Certificate of Appropriateness

2559 N. Wahl Avenue North Point North Historic District

Date issued 5/11/2022 PTS ID **N/A** COA: chimney repair

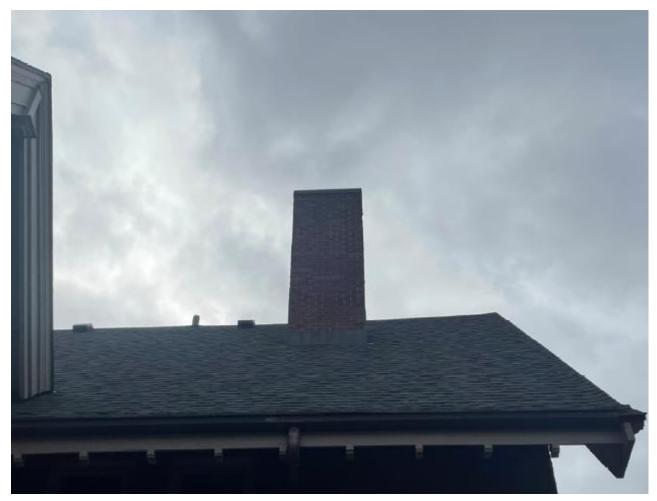
Masonry repairs to the main chimney and re-building the top to match the design on

the west chimney.

Chimney that will be repaired

The main chimney will be re-built to match the top of the west chimney

New mortar must match the original mortar in terms of color, texture, grain size, joint width, and joint finish/profile. The compressive strength of the repointing mortar shall be equal or less than the compressive strength of the original mortar and surrounding brick or stone. The replacement mortar shall contain approximately the same ingredient proportions of the original mortar. Mortar that is too hard is subject to premature failure and could damage the masonry. See the city's books *As Good As New* or *Good for Business*, Masonry Chapters, for more information. In most cases, this means a lime mortar with natural hydraulic cement rather than Portland cement. No joint of a width less than 3/8" may be cleaned of damaged/decomposed mortar with power disc grinders. No overcutting of the joints is permitted. Remove decomposed mortar back into the wall 2.5 times the height of the joint before repointing. When installing new flashing at a masonry feature, the flashing must be stepped or cut into the mortar joints. The bricks may not be cut to install flashing at an angle.

New brick/stone/terra cotta must match as closely as possible the color texture, size, and finish of the original. A sample panel of the masonry materials and their mortar must be reviewed and approved by HPC staff prior to general installation of the material.
